Class 2 Permit Modification Request
Removal of Deteriorating/Non-Essential Water Level Monitoring Program Wells

**Waste Isolation Pilot Plant
Carlsbad, New Mexico**

WIPP Permit Number - NM4890139088-TSDF

August 2019

Figure 1. Proposed Changes to Wells in Permit Figure L-14, *Groundwater Level Surveillance Wells*

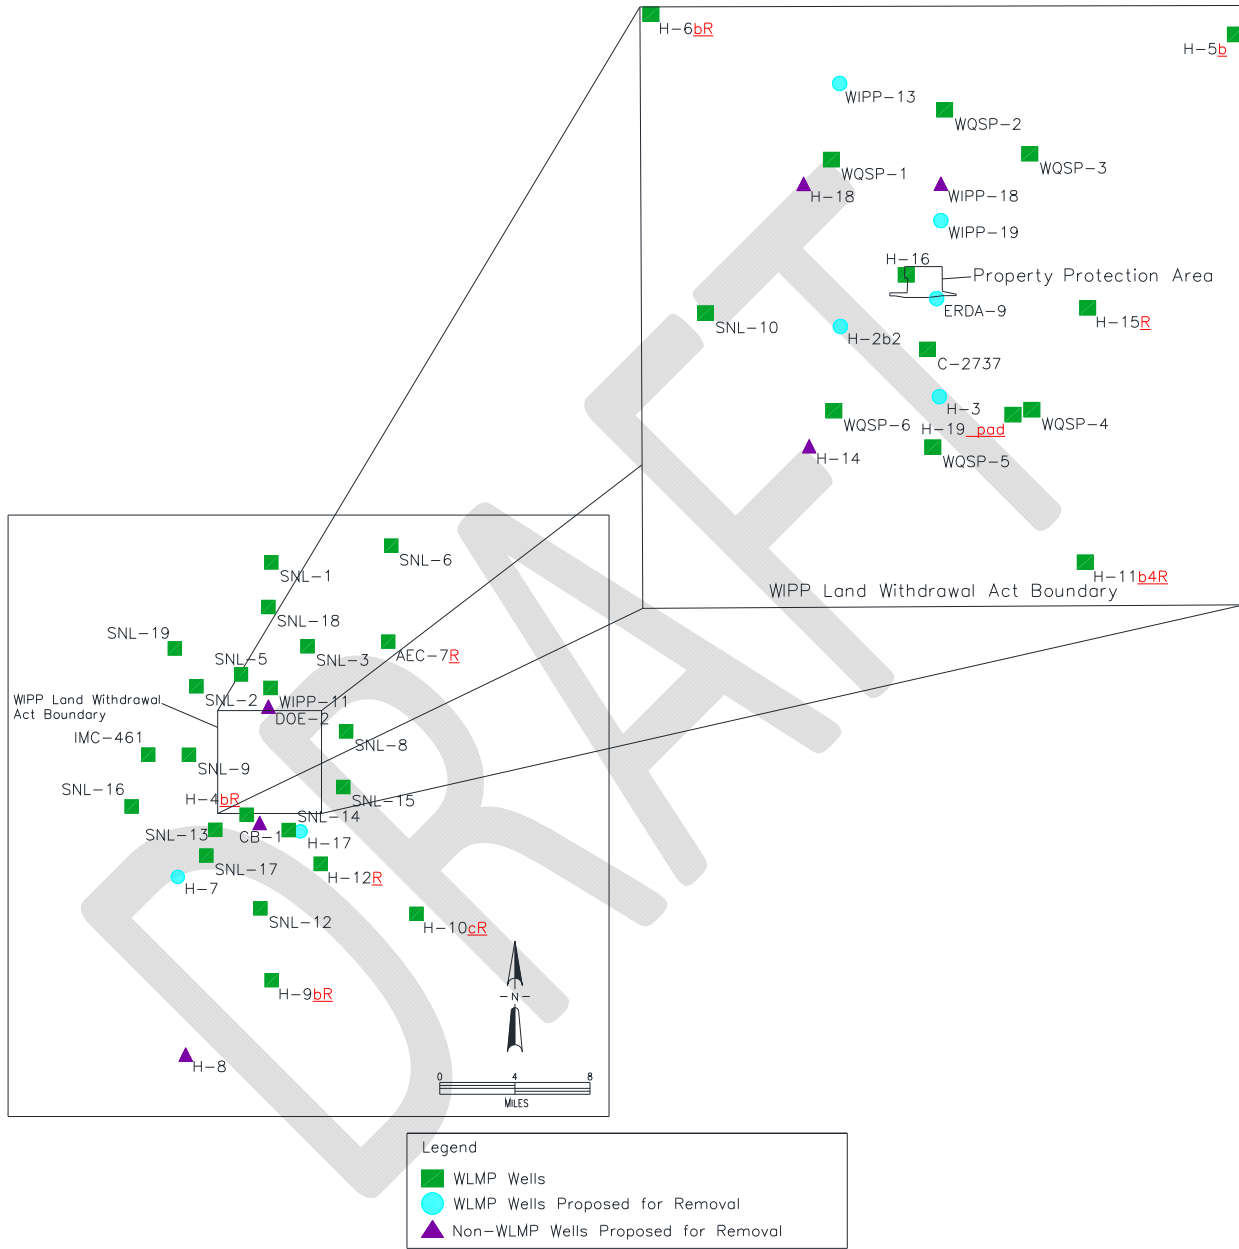
The Permittees are proposing to remove the WLMP wells listed below from Permit Attachment L, Table L-4, *List of Culebra Wells in the WLMP, Current as of October 2017* (as shown in Table 1) and Permit Attachment L, Figure L-14, *Groundwater Level Surveillance Wells* (as shown in Figure 1).

- Permit Attachment L, Figure L-14, *Groundwater Level Surveillance Wells*
 - Remove wells H-18, WIPP-18, H-14, DOE-2, CB-1, and H-8 (as shown in Figure 1).

- Modify the Exclusive Use Area boundary.
 - Delete “ASER 3-11-09” from the bottom right corner of the figure.
 - Change the well identification numbers (as shown in Figure 1) in the figure as follows:

- Replace “AEC-7” with “AEC-7R”
 - Replace “H-4” with “H-4bR”
 - Replace “H-5” with “H-5b”
 - Replace “H-6” with “H-6bR”
 - Replace “H-9” with “H-9bR”
 - Replace “H-10” with “H-10cR”

- Replace “H-11b4” with “H-11b4R”
 - Replace “H-12” with “H-12R”
 - Replace “H-15” with “H-15R”
 - Replace “H-19” with “H-19 pad”

- Permit Attachment L, Figure L-14, *Groundwater Level Surveillance Wells*
 - Wells H-18, WIPP-18, H-14, DOE-2, CB-1, and H-8 need to be removed from this figure because they monitor the Bell Canyon Formation and the Magenta Formation; the WLMP only consists of wells monitoring the Culebra, and as a result, wells H-18, WIPP-18, H-14, DOE-2, CB-1, and H-8 are not listed in Permit Attachment L, Table L-4. These wells had been included in the figure because they were part of the Annual Site Environmental Report in 2009. These wells need to be removed to provide an update to this figure and to assure accuracy and consistency with Table L-4.

- “ASER 3-11-09” needs to be deleted from the bottom corner of the figure because, with the proposed changes to the figure, it will become an incorrect reference.

Some of the well identification numbers need to be changed to ensure consistency with the identification numbers in Table L-4 and in the well permits issued by the New Mexico Office of the State Engineer, as listed in Permit Attachment B, *Hazardous Waste Permit Application Part A*, Appendix B1, *Other Environmental Permits*.

Figure L-2
WIPP Facility Boundaries Showing 16-square-Mile Land Withdrawal Boundary

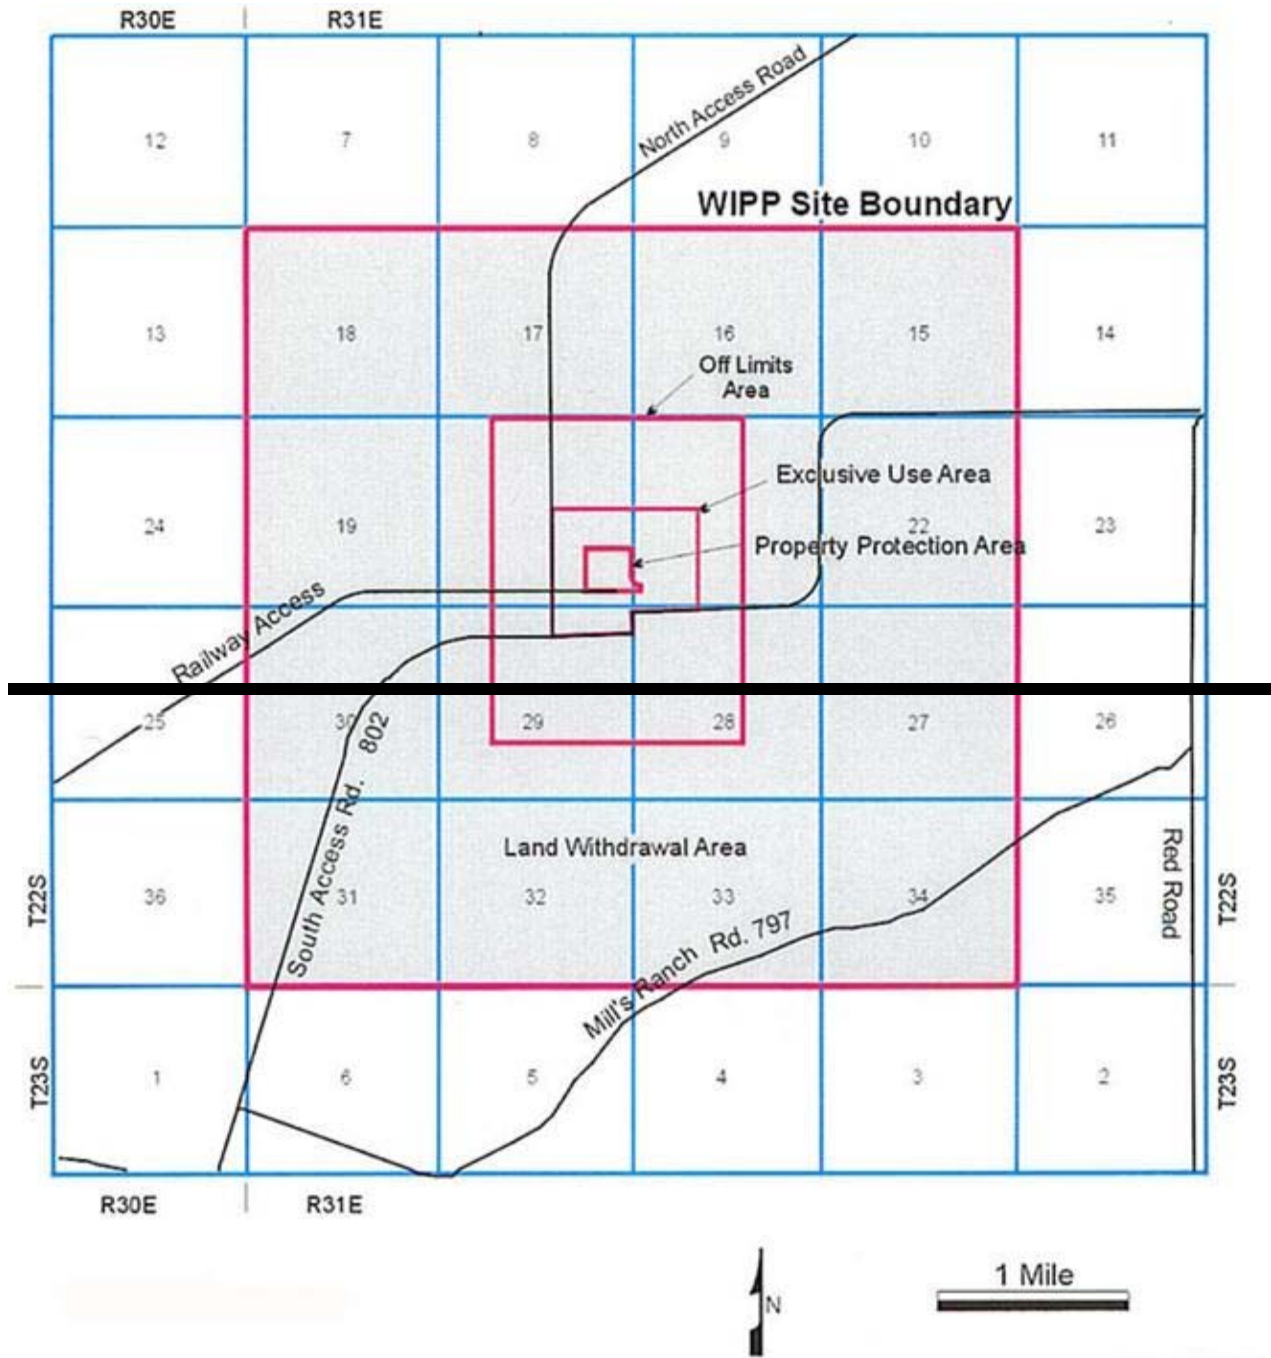
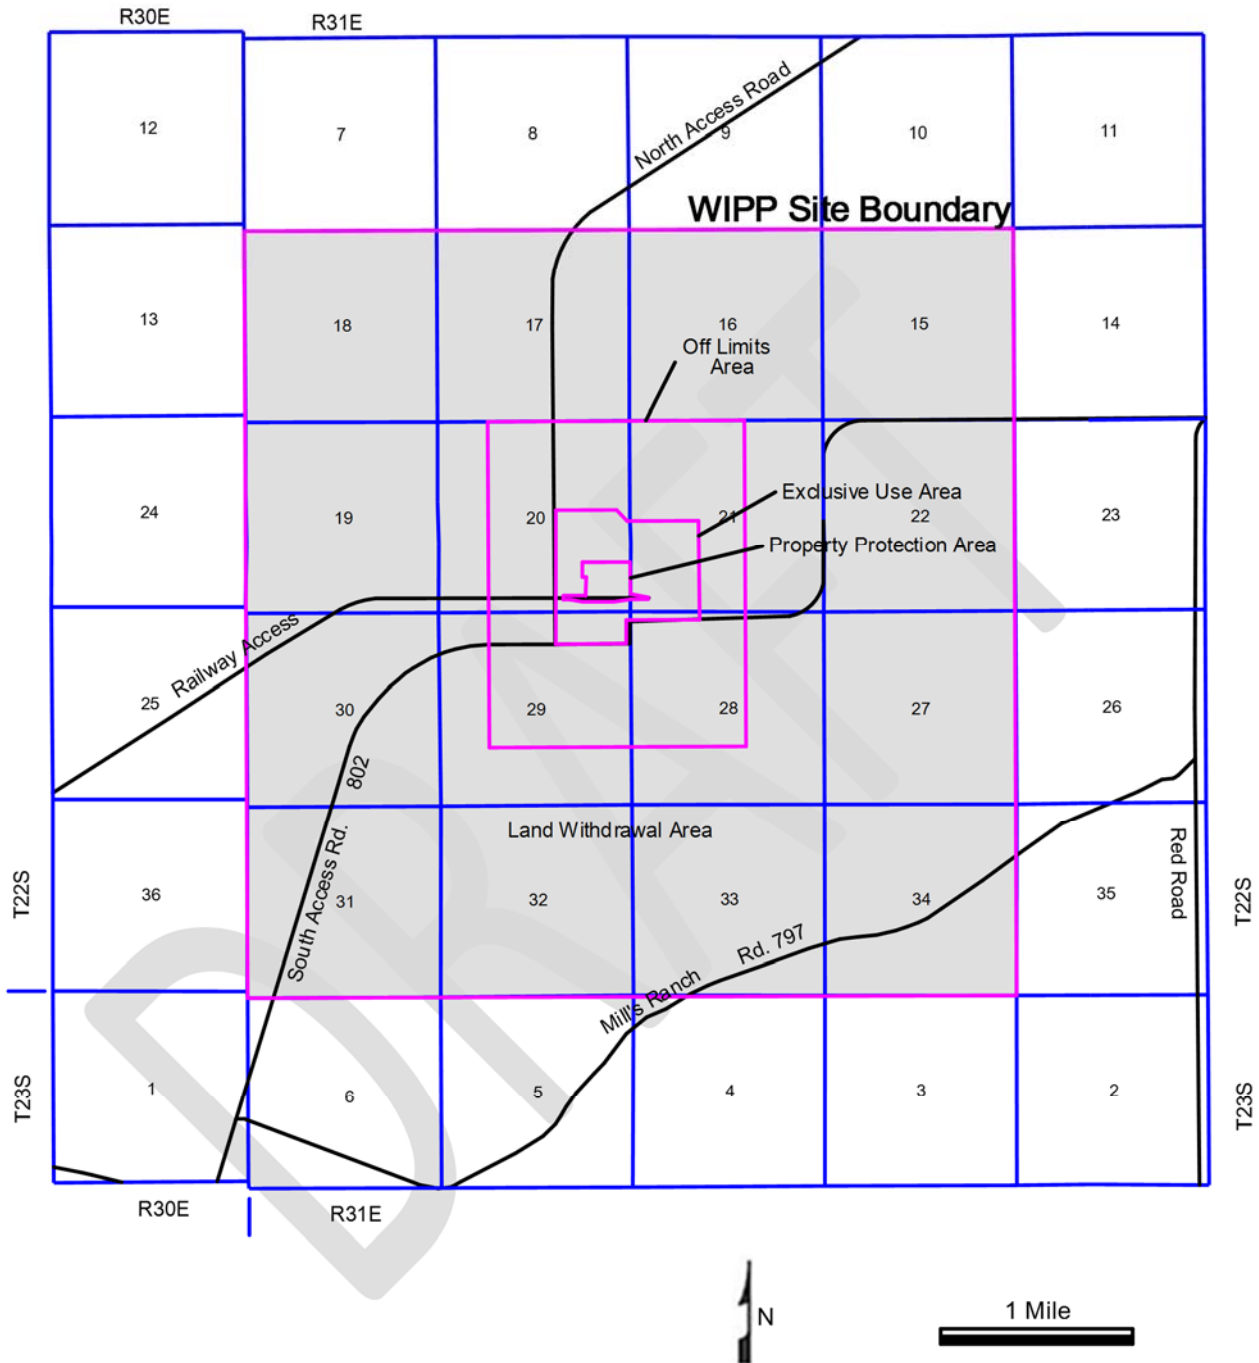
- Permit Attachment L, Figure L-2, *WIPP Facility Boundaries Showing 16-square-Mile Land Withdrawal Boundary* – Modify the Exclusive Use Area and Property Protection Area boundaries and add section labels for sections “20” and “21.”

- Permit Attachment L, Figure L-2, *WIPP Facility Boundaries Showing 16-square-Mile Land Withdrawal Boundary* – The Exclusive Use Area and Property Protection Area require modification to more accurately depict the boundaries and ensure consistency with the Property Protection Area boundary in Figures L-6 and L-14. In addition, missing section labels need to be added for sections “20” and “21” for completeness.

Figure L-6
Detection Monitoring Well Locations

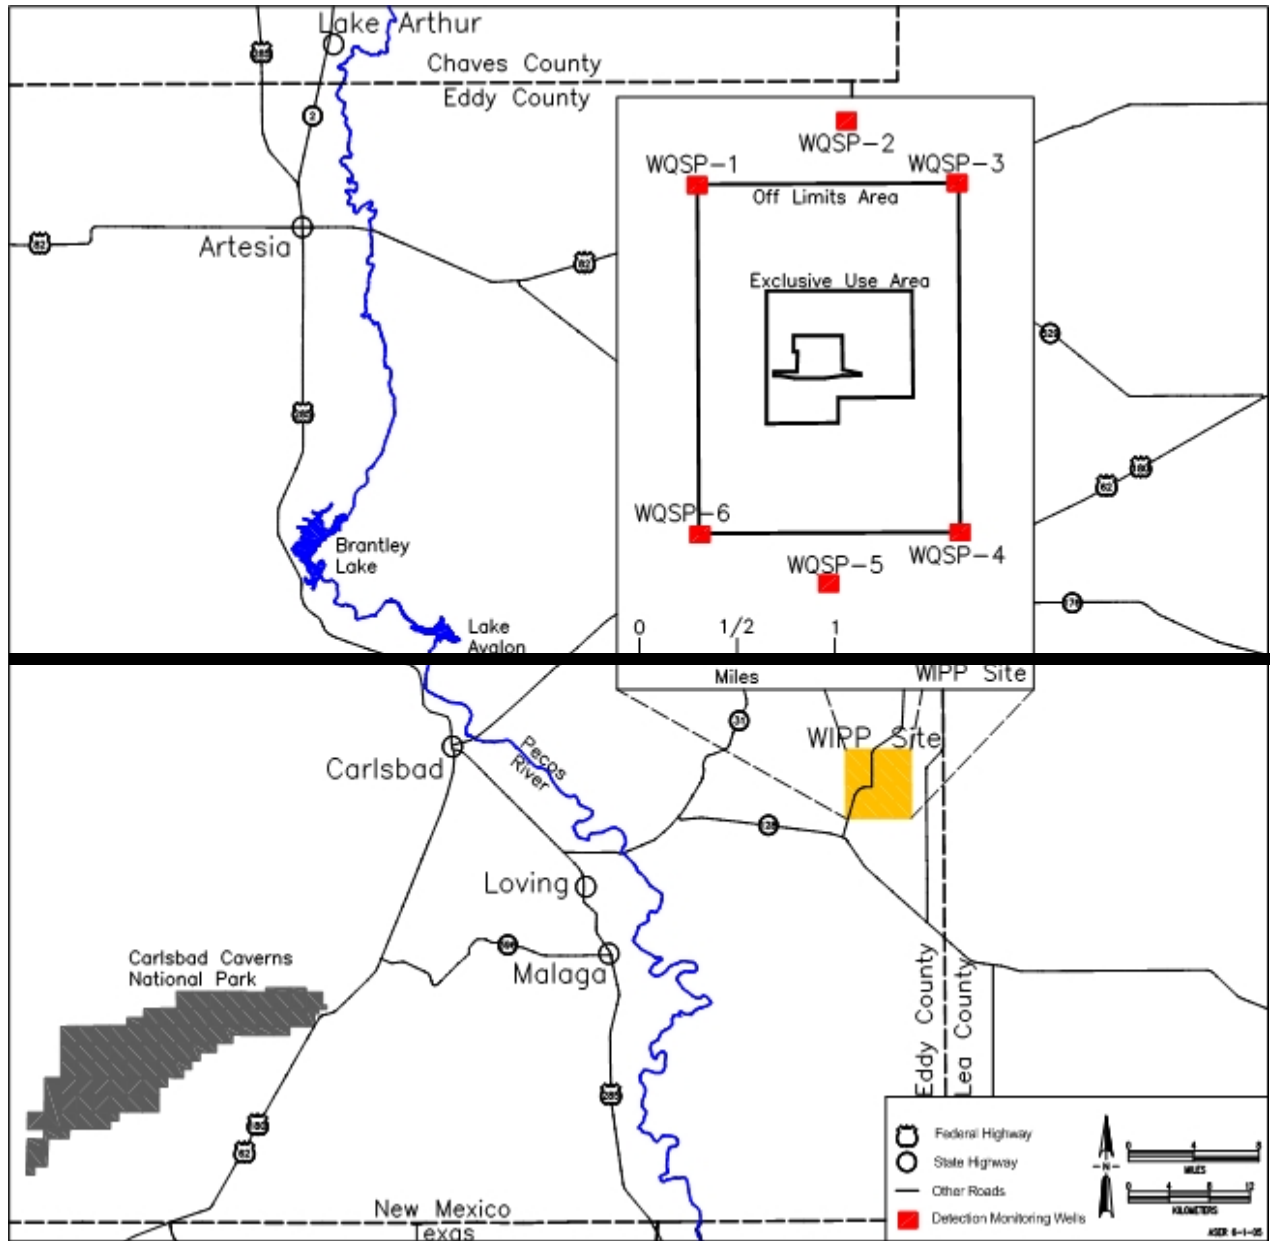
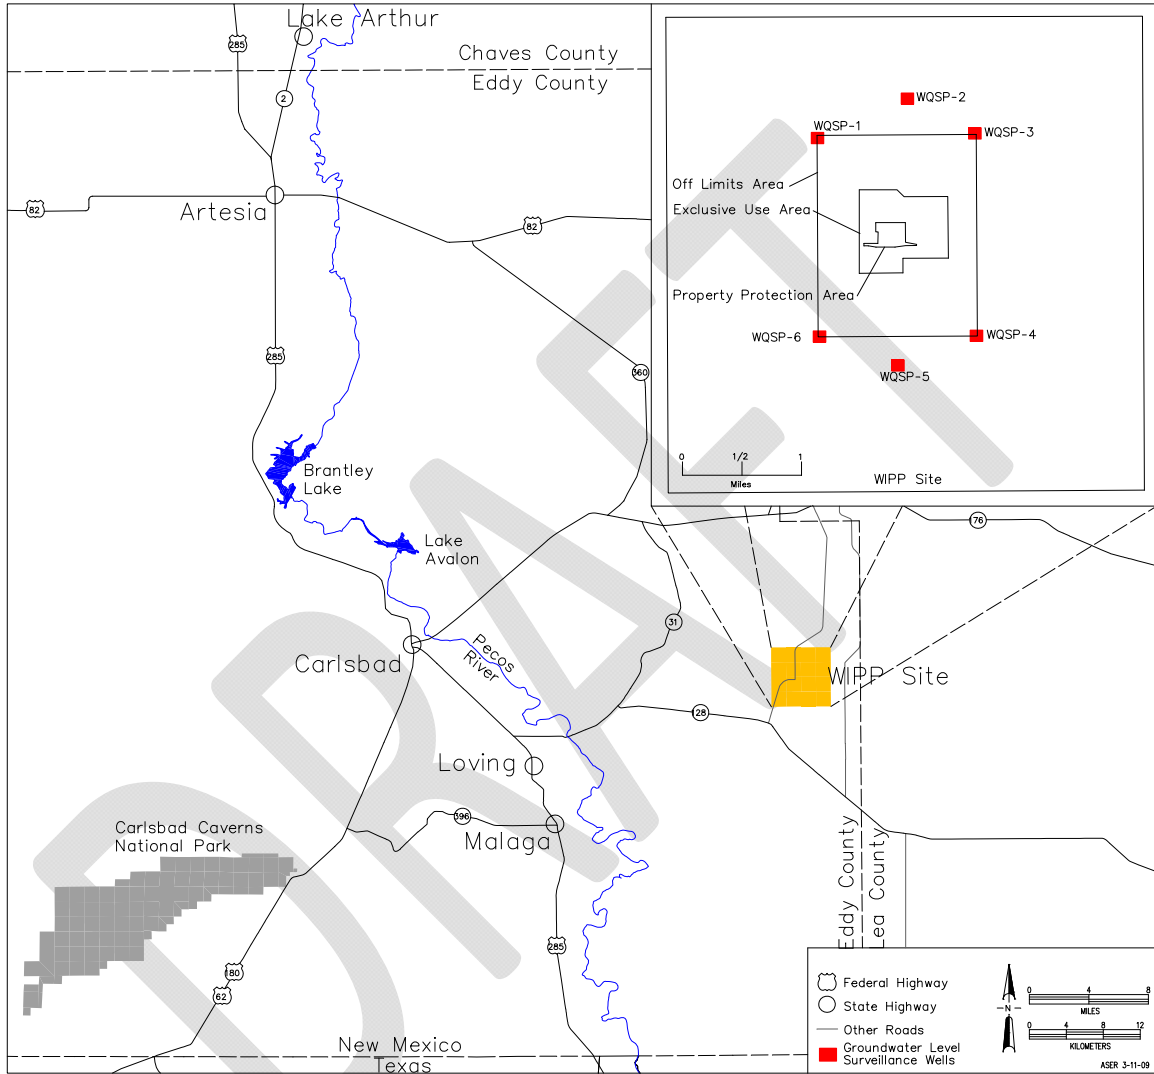
- Permit Attachment L, Figure L-6, *Detection Monitoring Well Locations* – Modify the Exclusive Use Area boundary and the figure labels for “WIPP Site,” “Exclusive Use Area,” “Property Protection Area” and “Off Limits Area.”

- Permit Attachment L, Figure L-6, *Detection Monitoring Well Locations* – The Exclusive Use Area boundary requires revision to provide a more accurate depiction, and the figure labels for “WIPP Site,” “Exclusive Use Area,” “Property Protection Area” and “Off Limits Area” need to be modified to enhance the clarity of the figure.
